DRAFT
Proposed Update to the
Shoreline Management Plan

April 26, 2024

Smith Mountain Pumped Storage Project FERC No. 2210

Shoreline Management Plan

FIGURE 1
STEP ONE – DETERMINATION OF SETBACKS

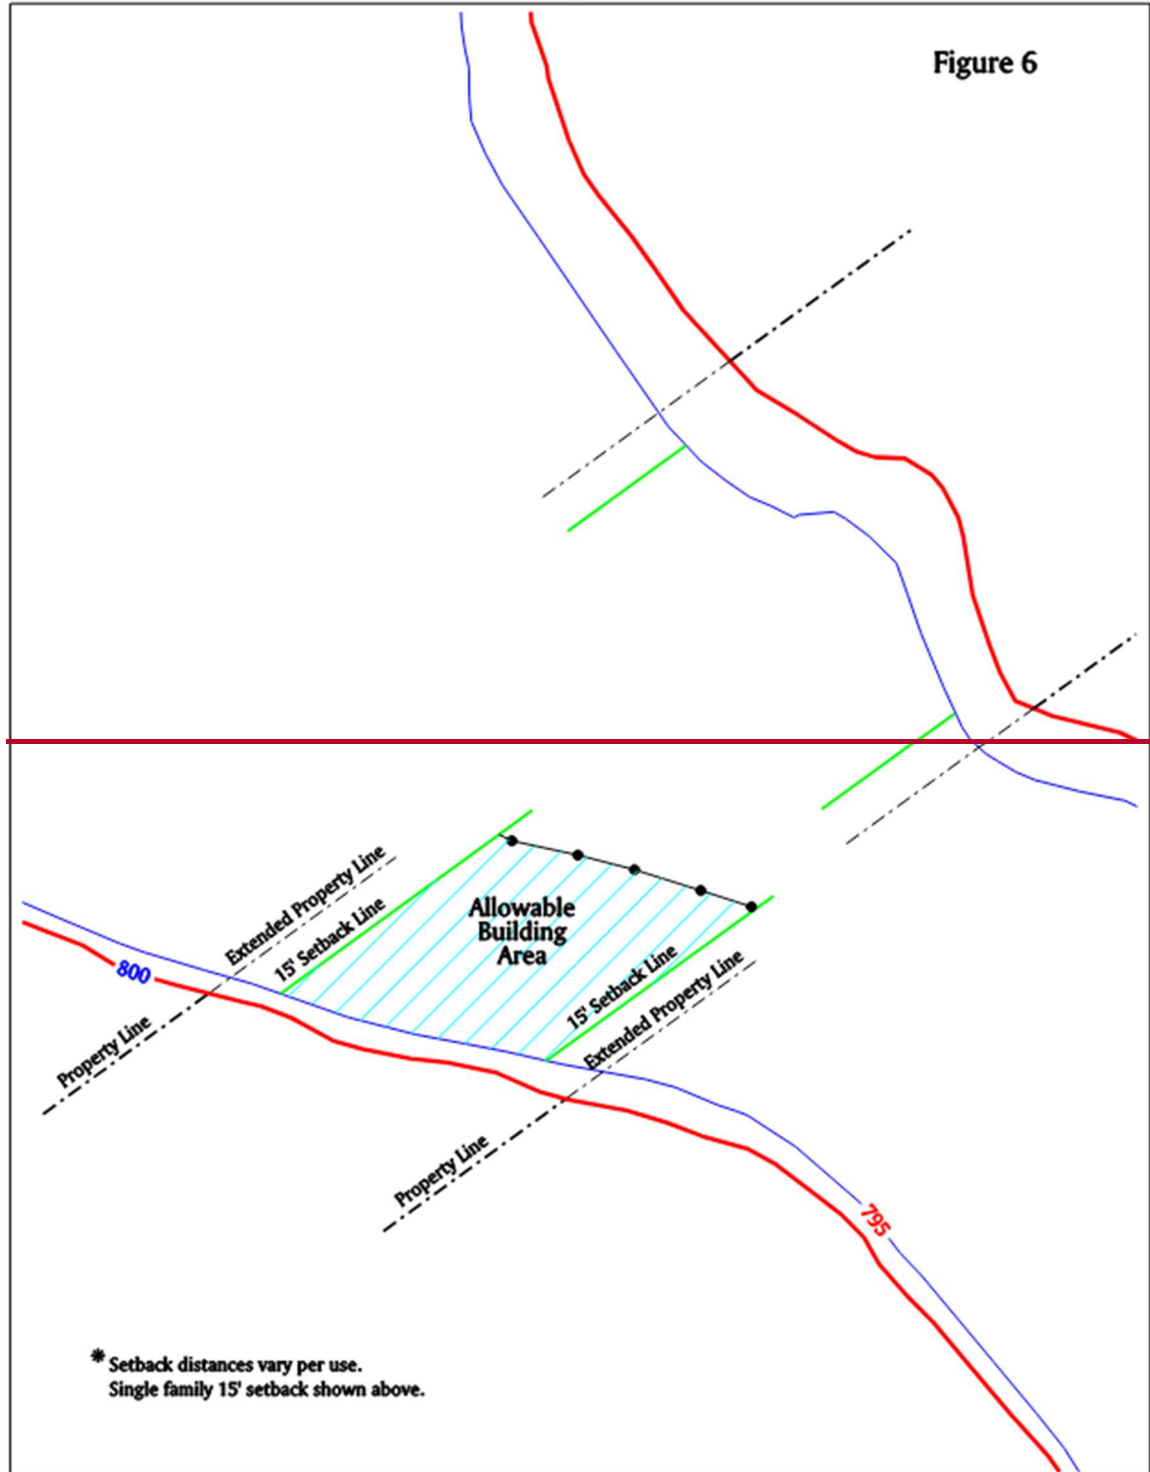
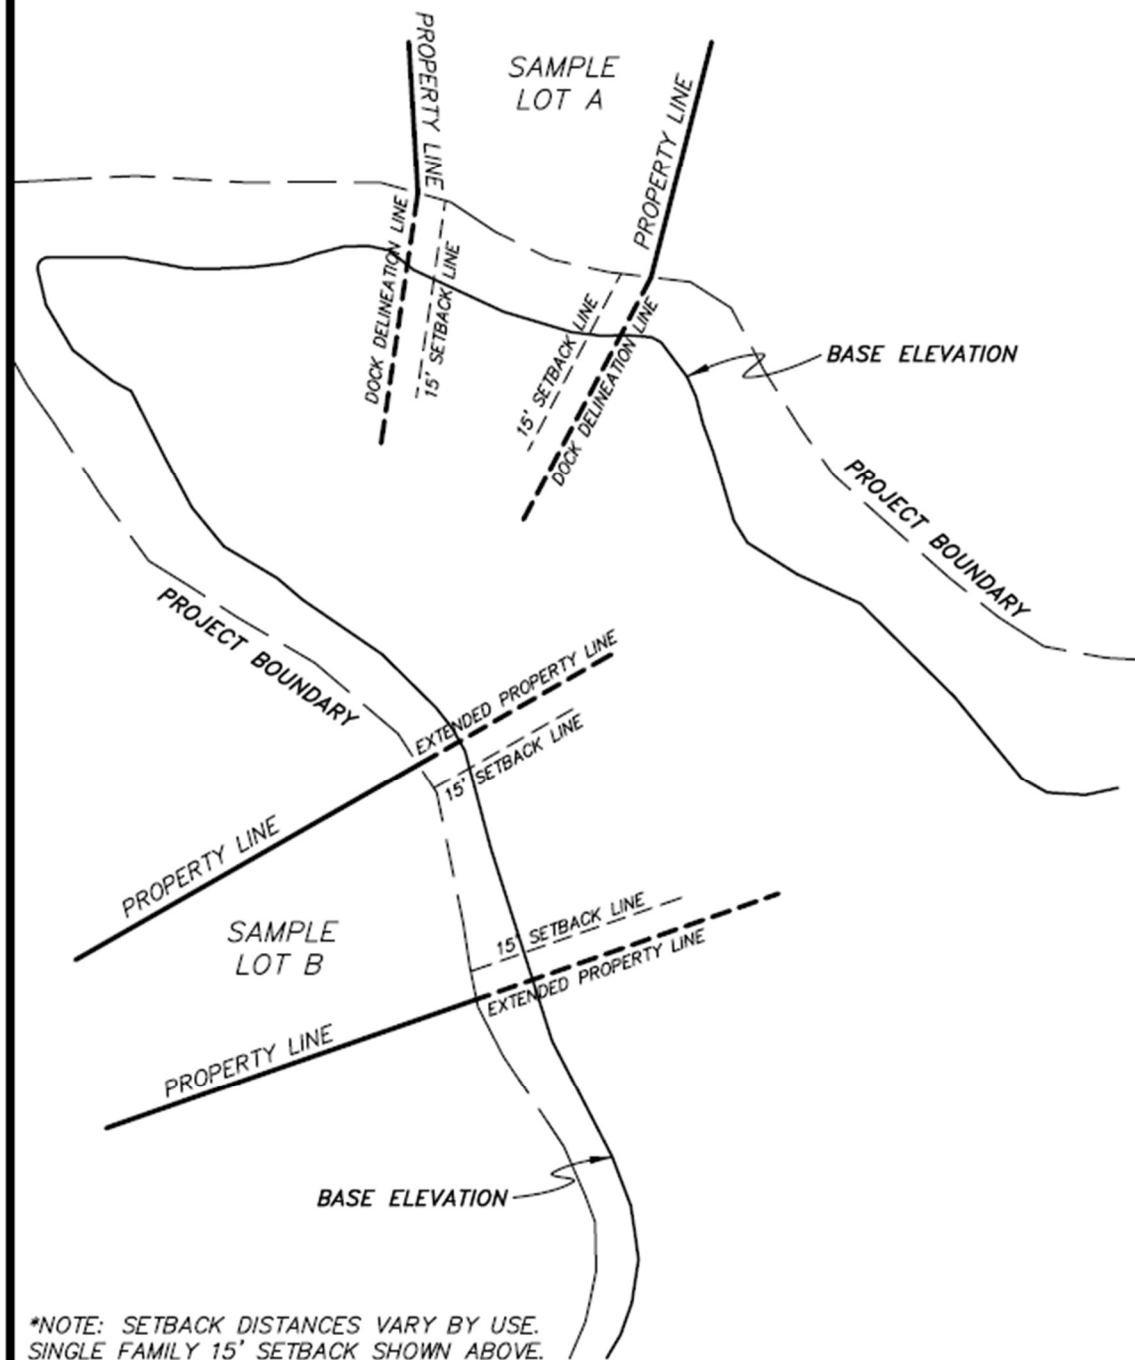
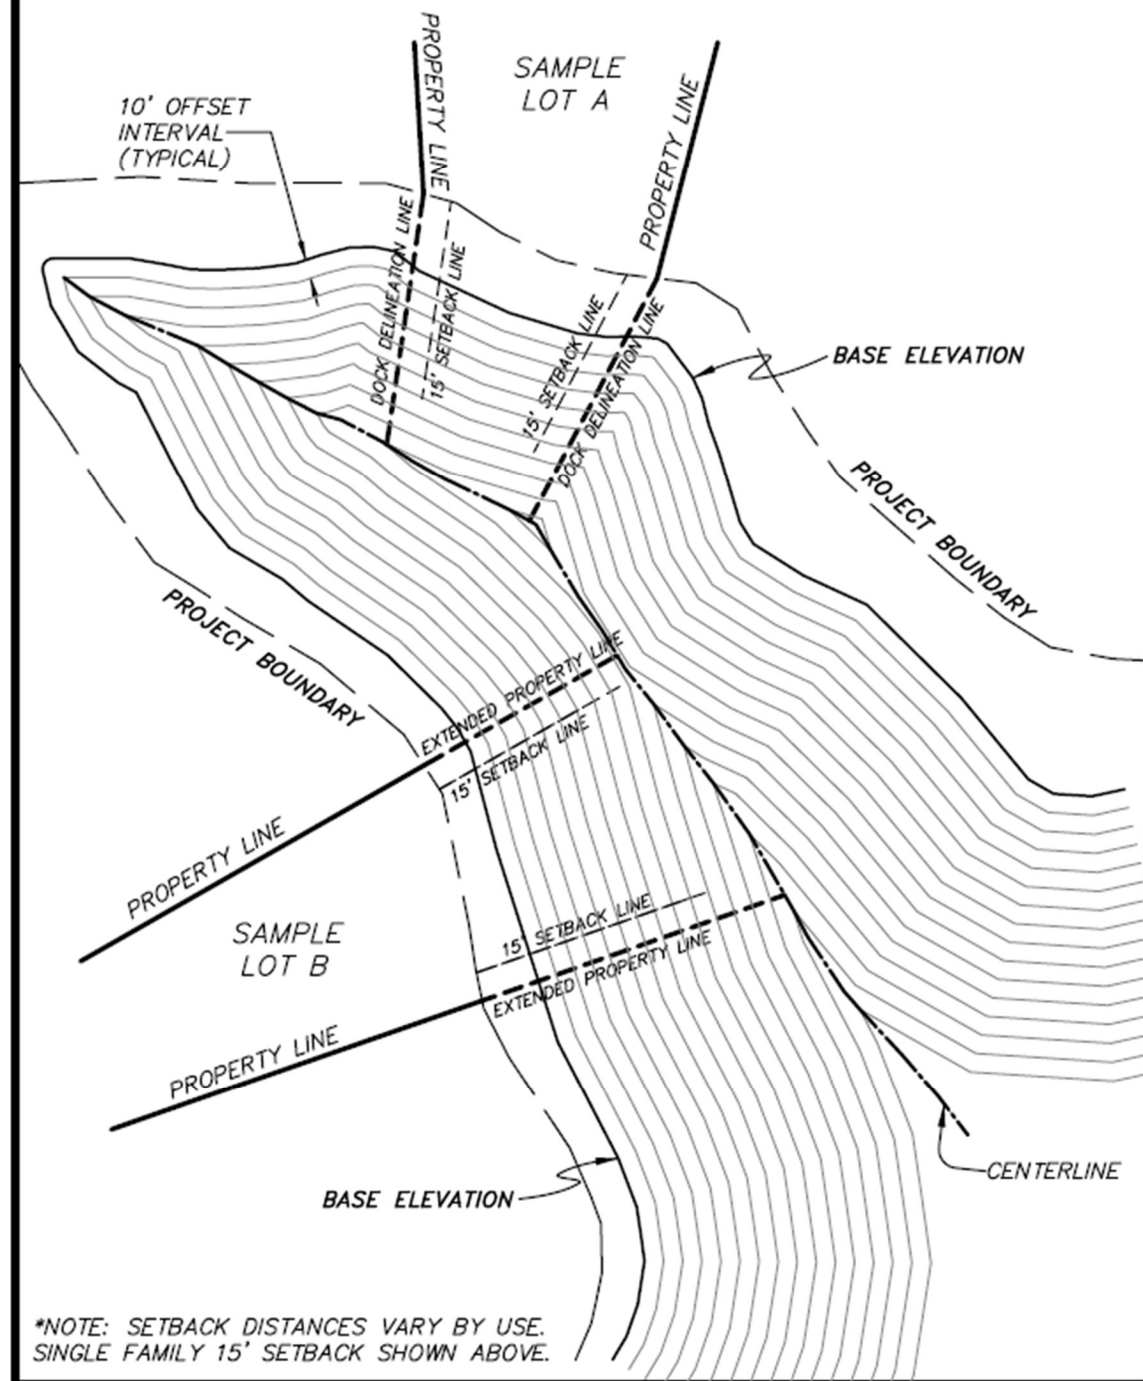
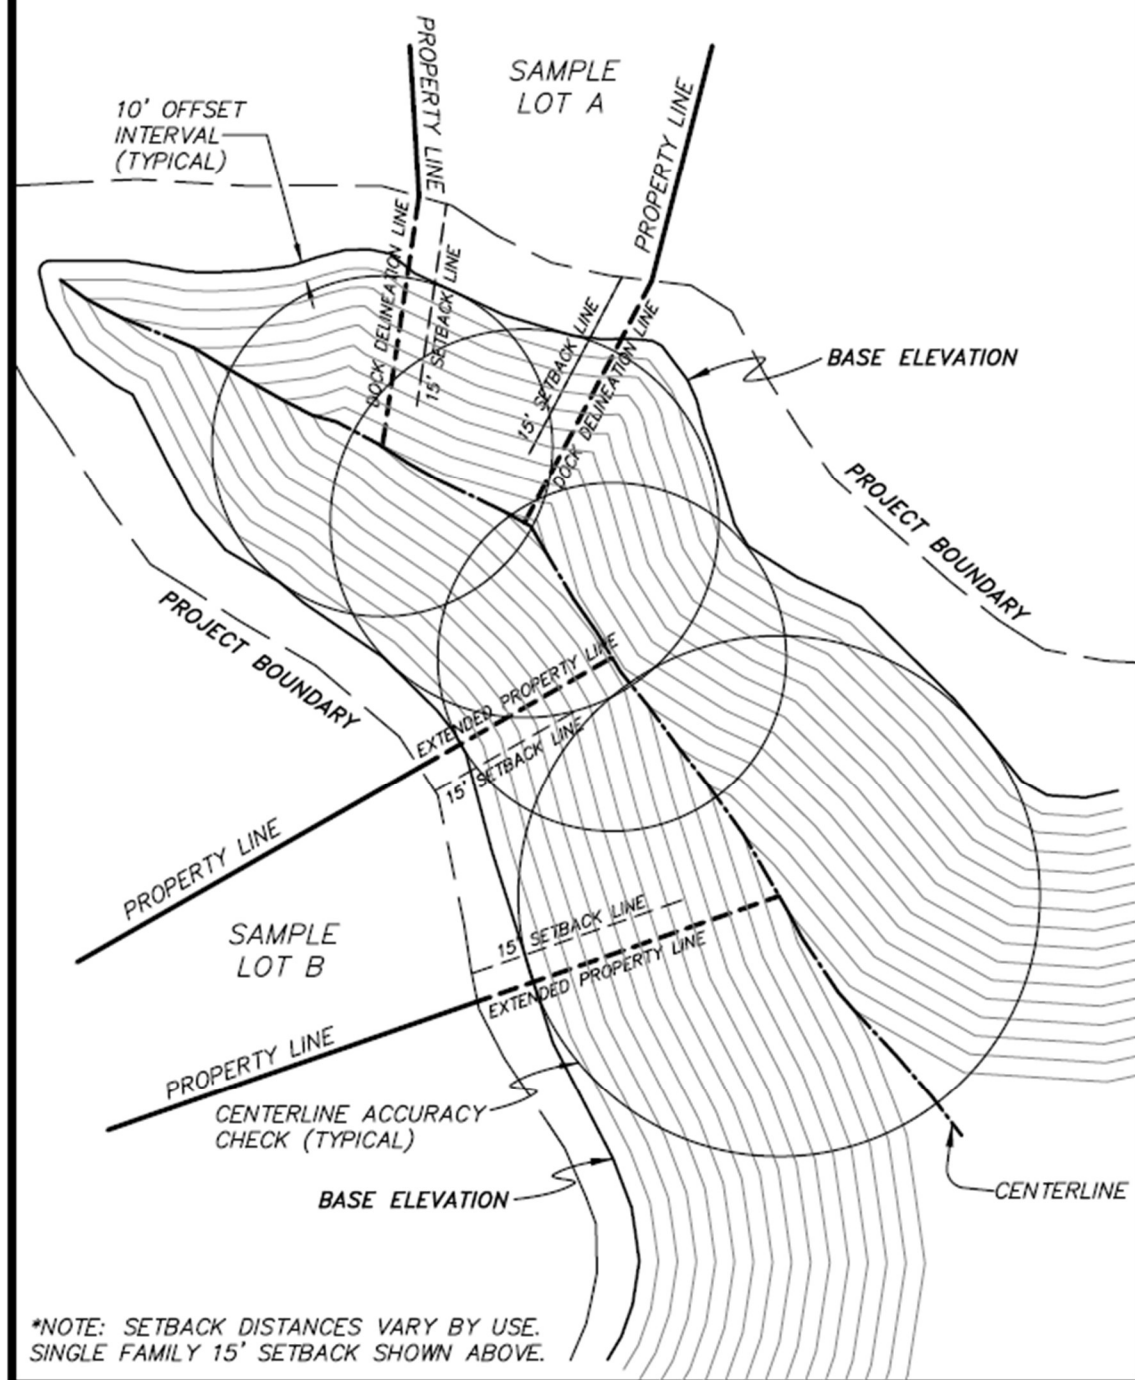
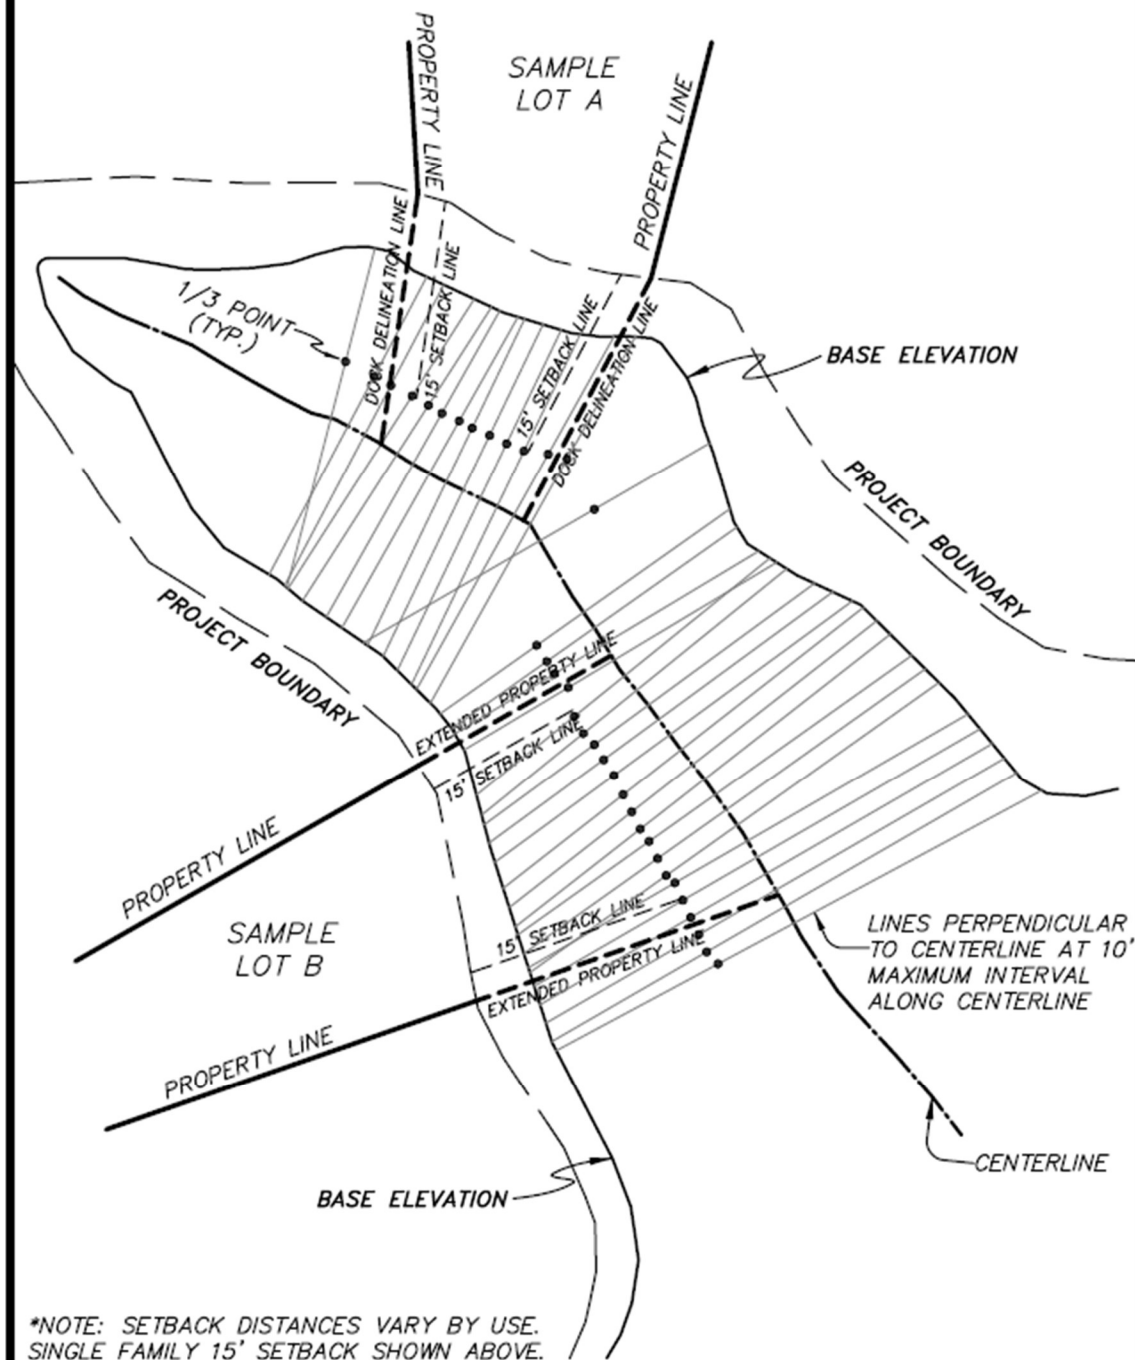
~~b. Step Two – Determination of Closest Points from Shoreline (Figure 2 to Appendix E)~~

e. — Step Three — Determination of Closest Points from Opposite Shoreline (Figure 3 to Appendix E)

Step Four — Determination of Waterway Centerline (Figure 4 to Appendix E)

b. Step Two – Determination of Waterway Centerline (Figure 2 to Appendix E)

To demonstrate the accuracy of the centerline, Appalachian may require additional information as depicted in Figure 2A of Appendix E. If required by Appalachian, extend the subject property's dock delineation lines (or extended property lines) to the centerline of the waterway. At each point where the dock delineation line (or extended property line) intersects the centerline, draw a circle with the shortest possible radius so that the circle is tangent to the base elevation on both sides of the cove. If the circle is not tangent to the base elevation on both sides of the cove, the centerline may be incorrect.
